Recall Campaign Bulletin

Campaign No. 2024060009, June 2024

SUBJECT: **Model C-Class (206 platform)**
Model Year 2023

Check AMG Performance Seat Wiring Harness Routing

Figure 3 – NOT OK condition, shown on left and right front seats

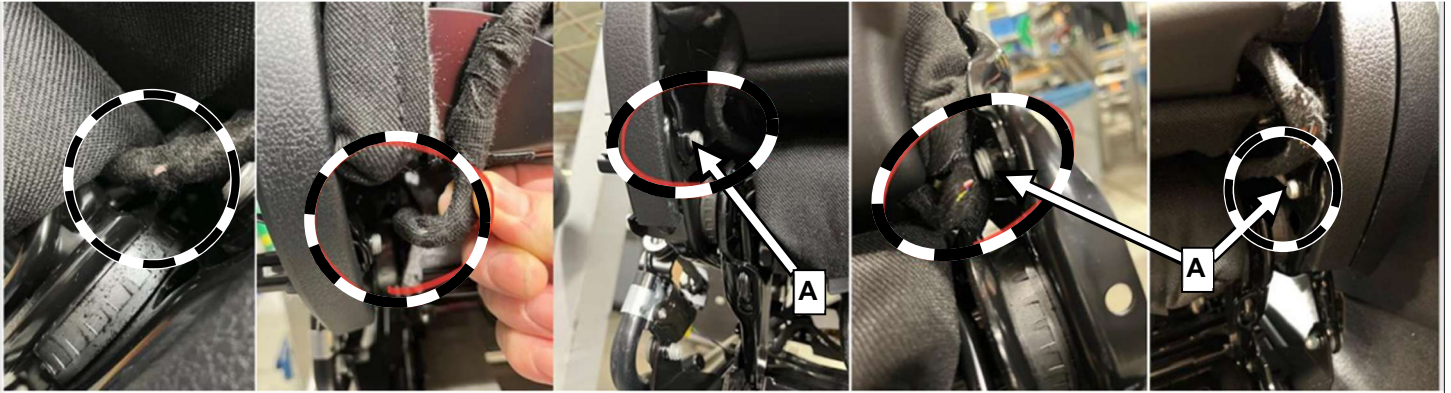
3. Check the seat wiring harness routing on the left side of driver seat and the right of front passenger seat (outboard sides) in the area of the backrest hinge screw (Figure 3, A):

- The seat wiring harness *is* damaged (Figure 3): Perform **Work Procedures A and B**.
- The seat wiring harness *is not* damaged: Perform **Work Procedure B**.

- If the seat wiring harness is **damaged**, remove the corresponding seat and repair the wiring harness.
 - i** Remove/install the front seat (AR91.10-P-1000WT) and repair the wiring harness (AR00.19-P-0100-09A).

Figure 5 – fastening clip is secured to sheet metal area without felt (Figure 5, green outline).

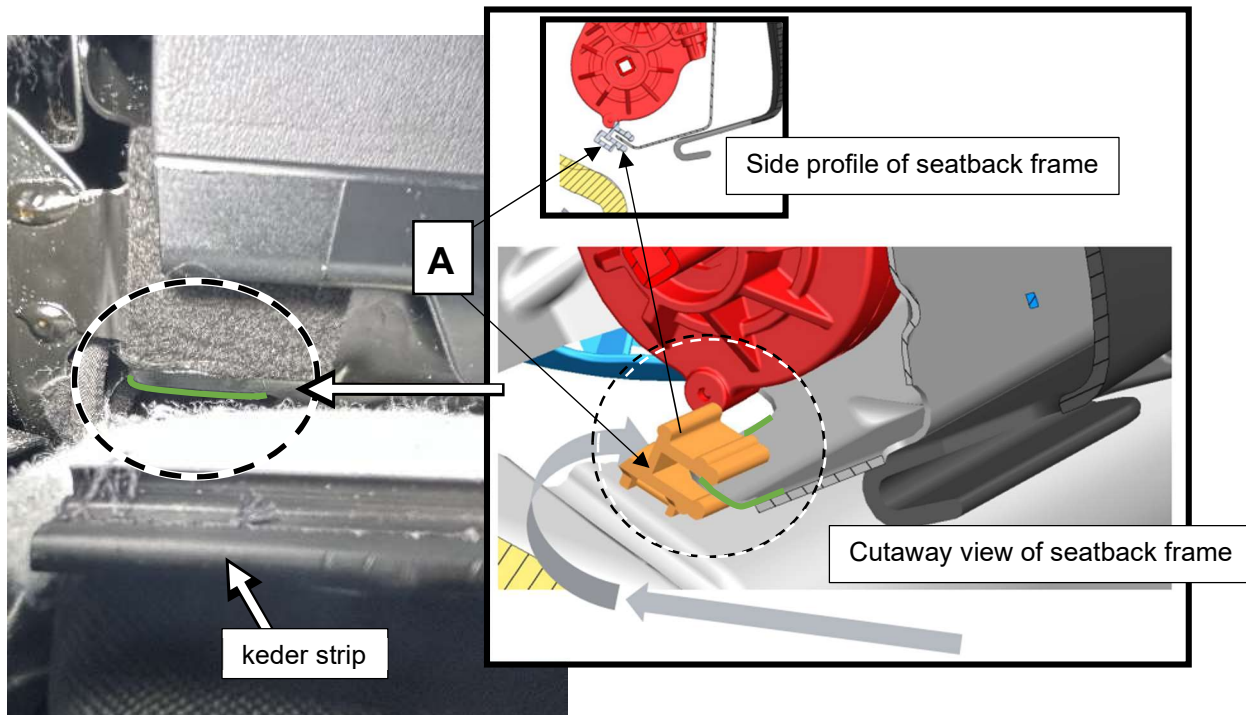
- Attach a cable tie with fastening clip to secure the wiring harness to the seat backrest frame. The seat backrest frame sheet metal has felt applied, and a section measuring 2-3mm **without felt** (Figure 5, green outline). Attach the fastening clip (Figure 5, A) flush to the outer edge of the sheet metal without felt and secure it flush against the sheet metal in the direction shown (Figure 5 and 6).

Figure 6 – cable tie routed through fastening clip eyelet.

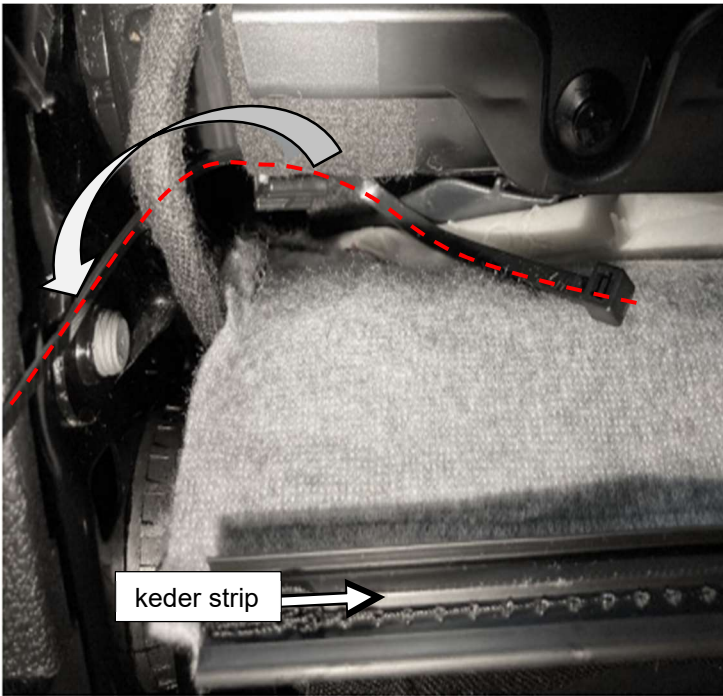
NOTE: The cable tie (Figure 6, red dashed line) is routed behind the seat backrest frame, through the eyelet of the fastening clip (Figure 5, A), and around the seat wiring harness to secure it from damage.

Figure 7

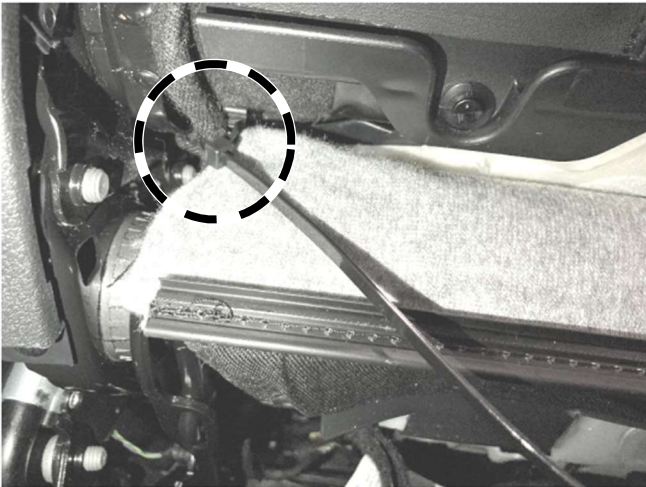
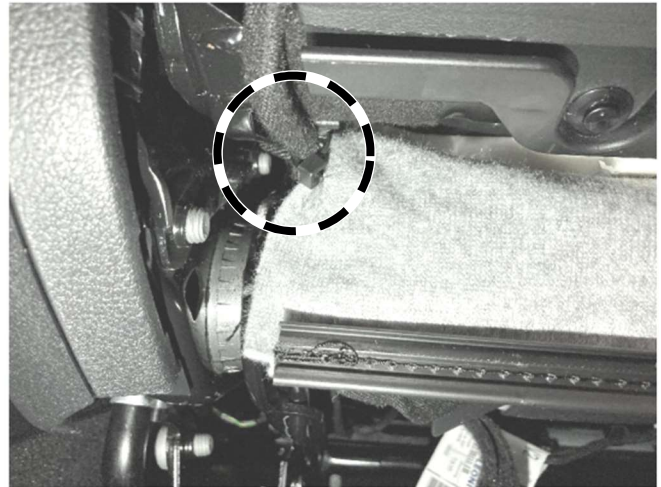
2. Tighten the cable tie and cut off any protrusion (Figure 7). Check the cable tie clip to ensure that it is secured.
